Office Action Summary	Application No. 10/815,149	Applicant(s) VANDENBROEK ET AL.	
	Examiner THOMAS MCEVOY	Art Unit 3731

DETAILED ACTION

3. Claims 10-18, 24-26 and 28 are rejected under 35 U.S.C. 102(a) as being anticipated by Yawata et al. (WO 2004/008944 A2).

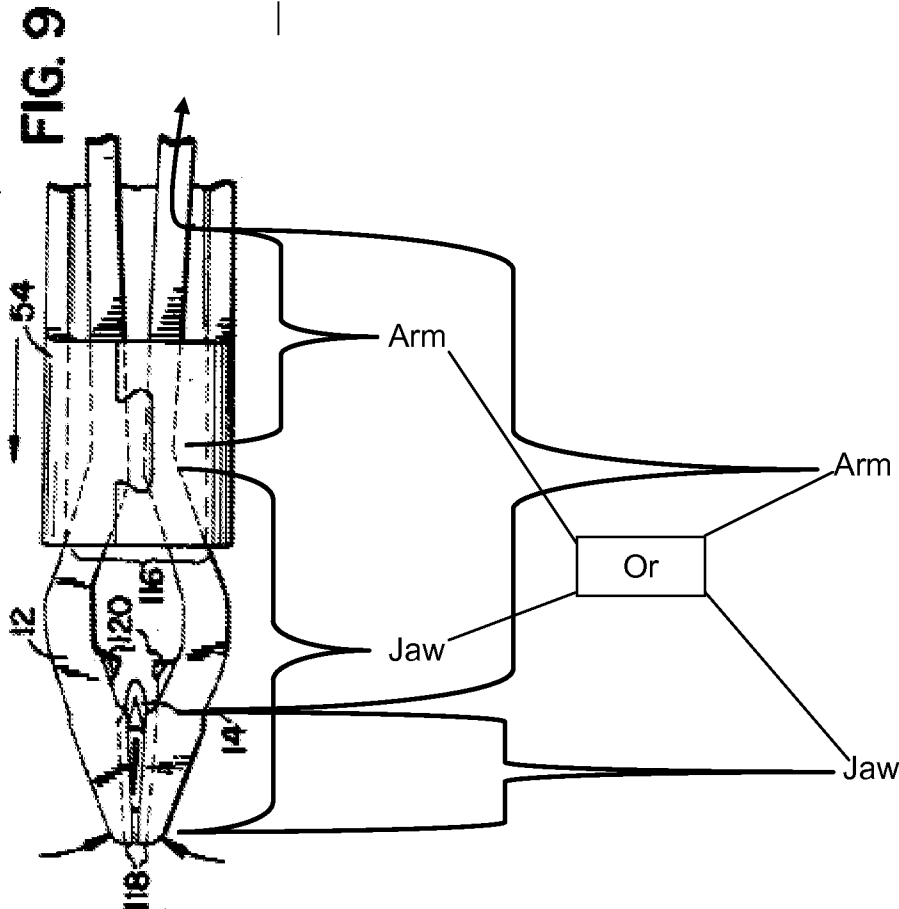
Regarding claim 10, Burbank et al. disclose a jaw assembly (capable of being a single clip jaw assembly) adapted for use with a handle assembly in a surgical clip applier, comprising: a pair of jaws 12 adapted to receive a surgical clip and movable between an open state and a closed state (Figure 8 vs. Figure 9); a pair of elongate support arms each adapted to support an associated one of the jaws between the open state of the jaws and the closed state of the jaws (Figure 9), see below:

The jaw assembly further comprises: a bridge (top of Figure 8 or 10) disposed between the support arms to hold the jaws in an aligned relationship between the open state and the closed state; a housing (54 or 16) disposed over at least the bridge, the housing having a generally fixed relationship with the bridge while permitting movement of the jaws between the open state and the closed state; and a coupling (proximal end 52 of 54; Figure 5) included in the housing, the coupling being adapted for attaching the housing to the handle assembly; wherein the jaw assembly is configured to receive only a single surgical clip at a time (the jaw assembly is capable of only receiving a single clip at time; however the jaw assembly is not incapable of receiving multiple clips), and the pair of jaws is adapted to receive a surgical clip exteriorly of the jaw assembly (the jaw assembly is capable of receiving a clip exteriorly of the jaw assembly). Regarding claim 11, the jaw, support arms and bridge contact each other and are therefore integral. Regarding claim 12, the claimed phrase "wherein the housing the molded over the bridge" is being treated as a product by process limitation; that is, as set forth in MPEP 2113, product by process claims are not limited to the manipulation of the recited steps, only the structure implied by the steps. Once a product appearing to be substantially the same or similar is found, a 35 USC 102/103 rejection may be made and the burden is shifted to applicant to show an unobvious difference. MPEP 2113. The housing 54 is found to be substantially the same or similar to the claimed housing. Regarding claims 13 and 14, the jaws are resilient and biased in the open position when not pushed together by 54 (Figure 8 vs. Figure 9). Regarding claims 15-18, the jaws open and close in a plane separating the top and bottom surfaces of the arms. In a

closed state, only the top and bottom surfaces of the arms can be in contact with the top and bottom sides (first and second portions) of the housing 54 and the side surfaces can be squeezed out of contact with the side surfaces of the housing as shown in Figure 9. Regarding claim 27, the arms can extend through the housing as diagramed above. The bridge forms the back of the jaw assembly and extends to the handle. Regarding claim 28, the housing is capable of not receiving any surgical clips.
